Date: March 29, 2021

**Subject: Request for Proposal (RFP) No. 50318
Police Facility Needs Assessment Services
Addendum No. 2**

Addendum No. 2 is being issued to provide Metra's response to questions submitted by potential proposers. Addendum No. 2 outlines all written questions submitted and Metra's responses to these questions.

PLAT OF SURVEY

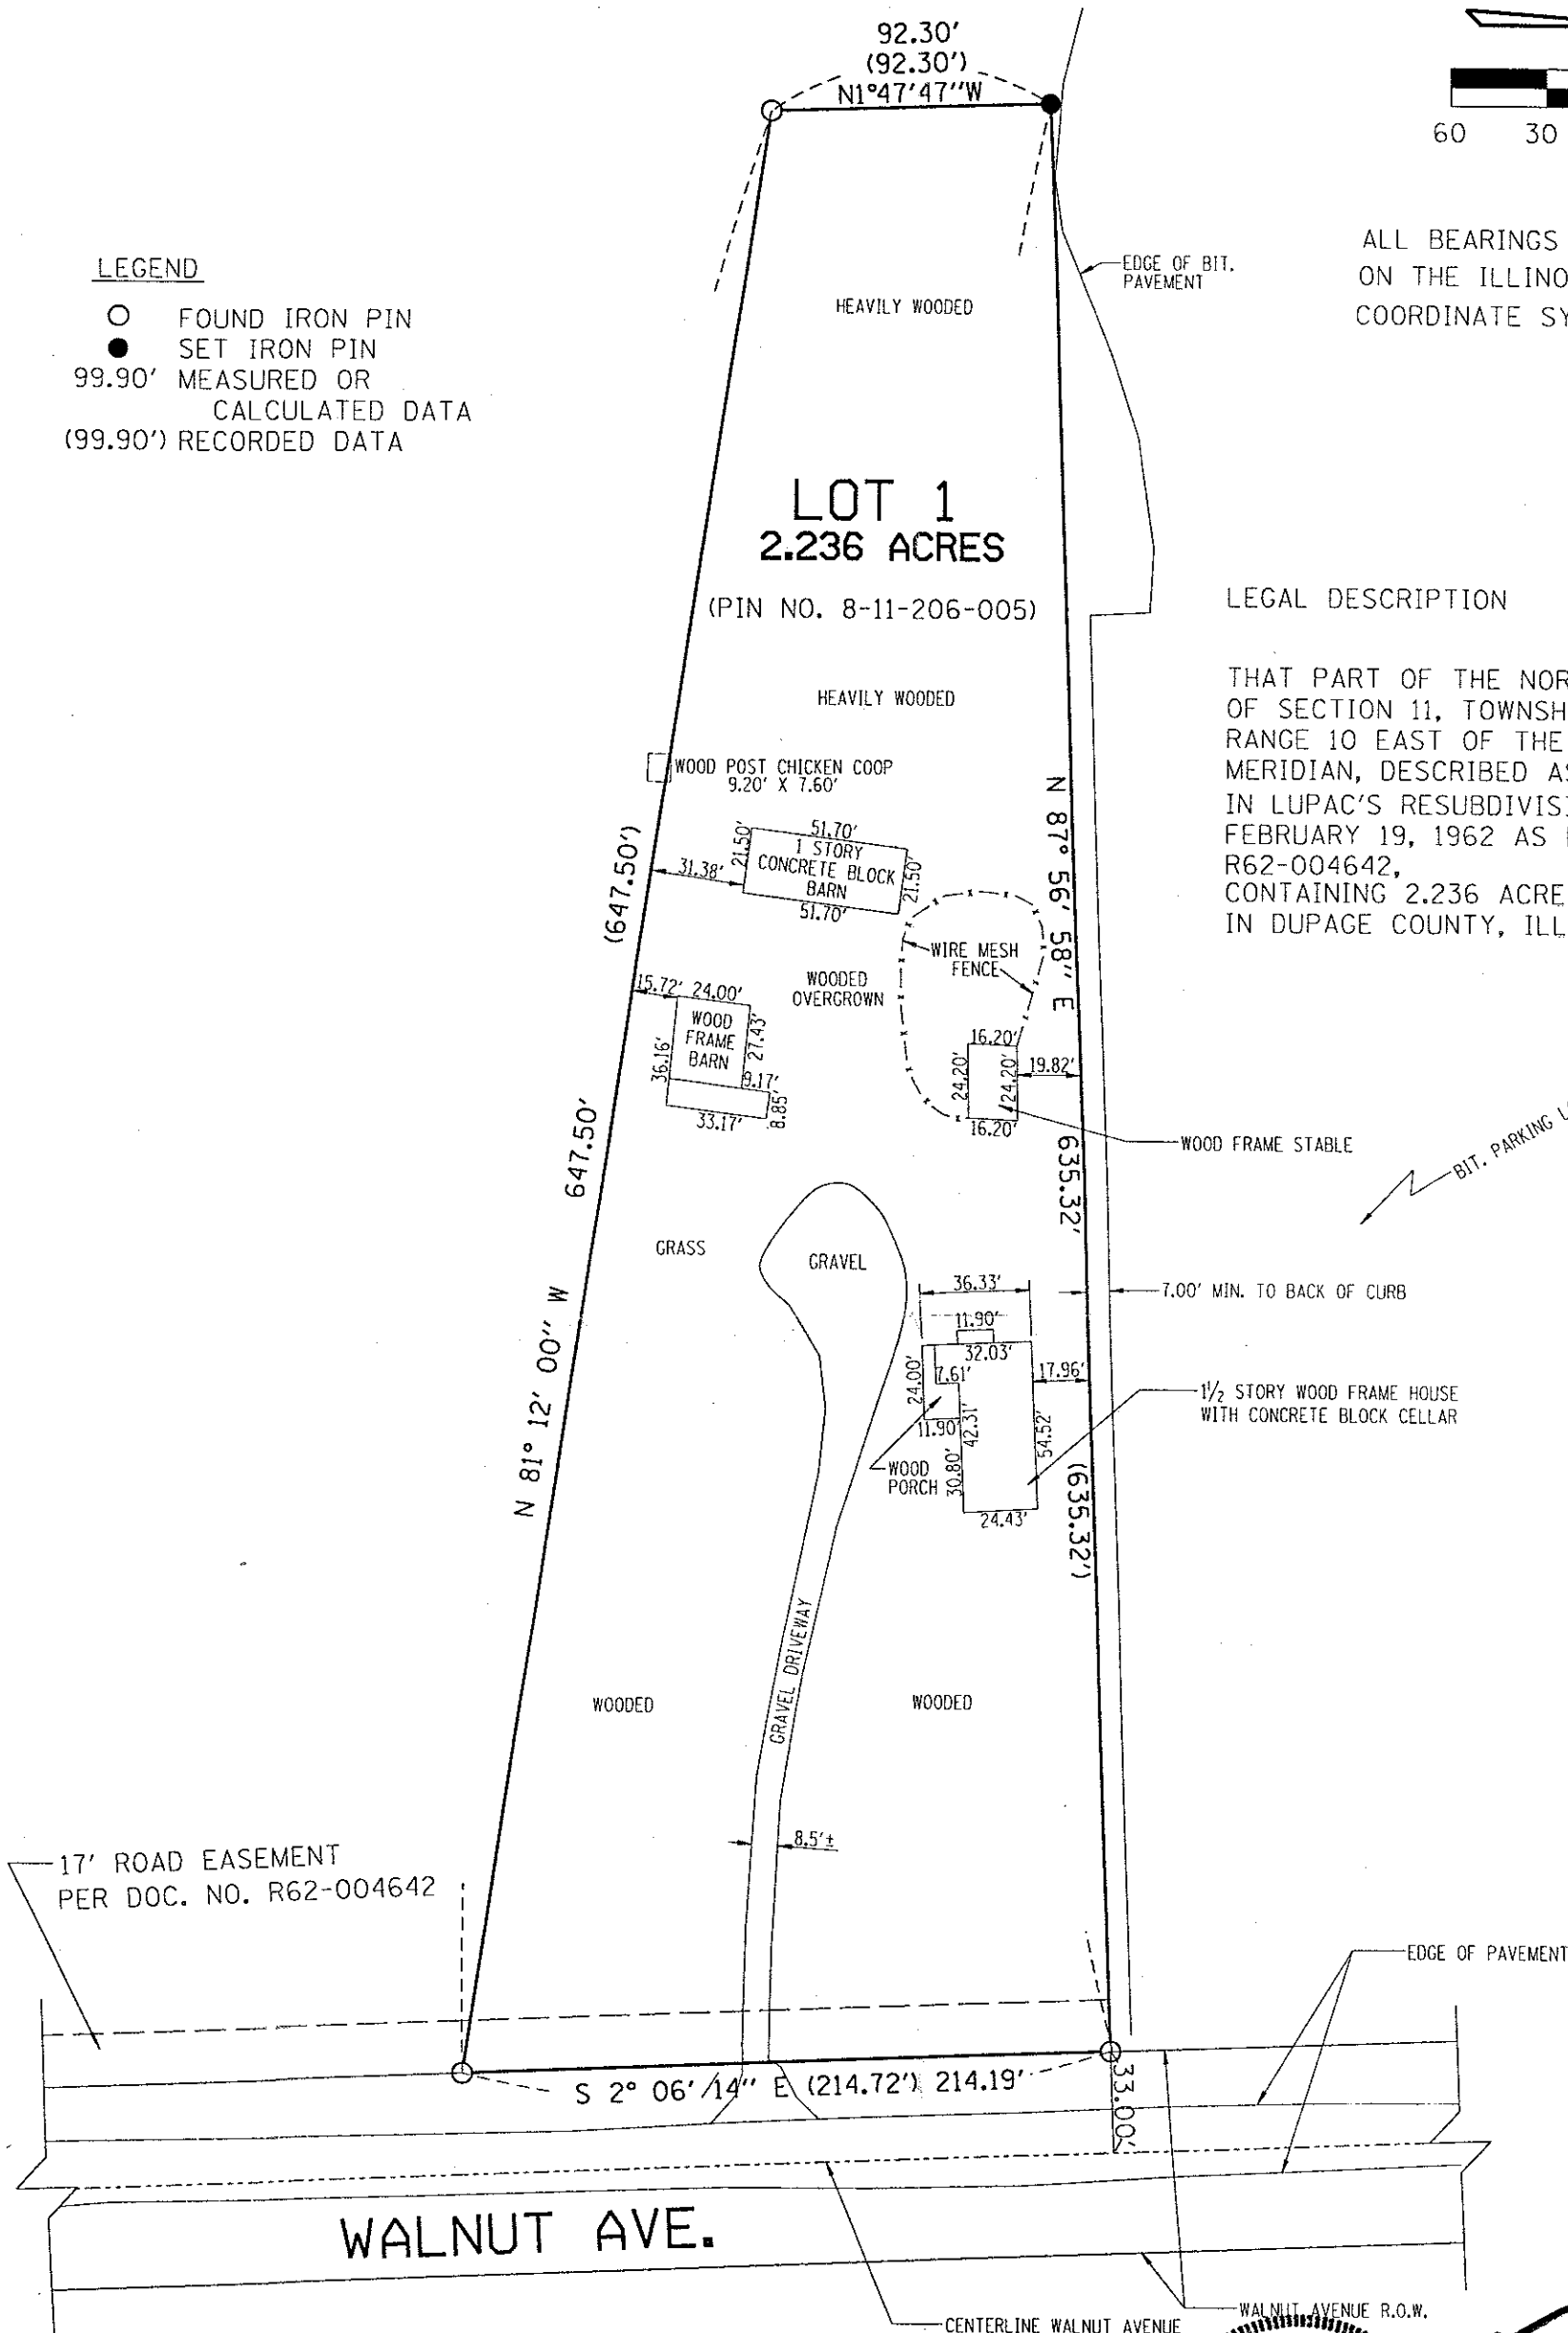
- Question 2: For us to provide a proposal, it would help if we had the following information: Site survey – this will give us the overall size of the site without having to estimate the borders from Google Earth. You should have at a minimum a boundary survey from the land purchase.

- Metra Response: See attached Exhibit 1-A, Appendix 2, Plat of Survey.
- Question 3: If you have other items, such as soil borings and an environmental study would be nice but are not absolutely necessary. Having this information allows for more accurate budgeting and helps to identify other potential obstacles or issues that will need to be dealt with in the future.
